Access Compliance Report

Public Rights-of-Way

Intersection ID: 18716	Main Street: COLONY_RD	Cross Street: RUNNYMEDE_LN	Location: NW
ADA ID: 1956E8741DFC	Ramp Type: BlendTrans1	Initial Pass/Fail: Fail	Overall Compliance: No
Severity Score: 12.5			
Codes/Mitigation Info/Possible Solution		Field Measurements/Component Compliance

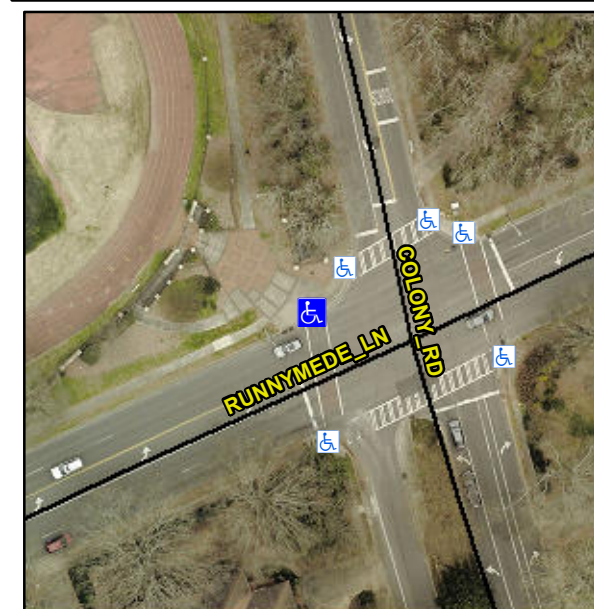
Remove & Replace Curb Ramp With Two New Directional Ramps or Equivalent.

XWALK PAVERS

Not Found, R304.5.3

Compliance	Description	Data	Compliance	Description	Data
N/A	Ramp Length (in)	48.0	Yes	BlendTrans Slope (%)	4.3
Yes	Ramp Width (in)	48.0	No	BlendTrans XSlope (%)	5.8
N/A	Flare Type LT	N/A	N/A	Flare Type RT	N/A
N/A	Flare Slope LT (%)	N/A	N/A	Flare Slope RT (%)	N/A
N/A	Flare Traversable LT?	N/A	N/A	Flare Traversable RT?	N/A
N/A	Landing Length (in)	N/A	N/A	DWS Provided?	N/A
N/A	Landing Width (in)	N/A	N/A	DWS Contrast?	N/A
N/A	Landing Slope (%)	N/A	N/A	DWS Length (in)	N/A
N/A	Landing X Slope (%)	N/A	N/A	DWS Full Width?	N/A
N/A	Landing Curb? (Y/N)	N/A	N/A	DWS Offset (in)	N/A
N/A	Shared Landing?	N/A			
N/A	Gutter Ponding?	N/A	N/A	Gutter Slope (%)	N/A
N/A	Gutter Lip Ht (in)	N/A	N/A	Gutter X Slope (%)	N/A
N/A	Painted X Walk1?	Yes	N/A	Painted X Walk2?	N/A
	X Walk 1 Direction	To S		X Walk 2 Direction	N/A
	X Walk 1 Width (in)	119.0		X Walk 2 Width (in)	N/A
	X Walk 1 Slope (%)	3.8		X Walk 2 Slope (%)	N/A
	X Walk 1 X Slope (%)	3.5		X Walk 2 X Slope (%)	N/A

N/A	Ramp inside XWalk1?	Yes	N/A	Ramp inside XWalk2?	N/A
	Road Slope (%)	3.5		Clear Space?	N/A
	Road X Slope (%)	3.8	N/A	Clear Space to XWalk (in)	N/A
N/A	Any Obstructions?	N/A	N/A	Storm Grate/Utility Hazard?	N/A
	Obstruction Type			Storm Grate/Utility Type	
		N/A			N/A
		Yes		Surface Condition? (G/P)	Good
		No		Curb Slope (%)	9.2
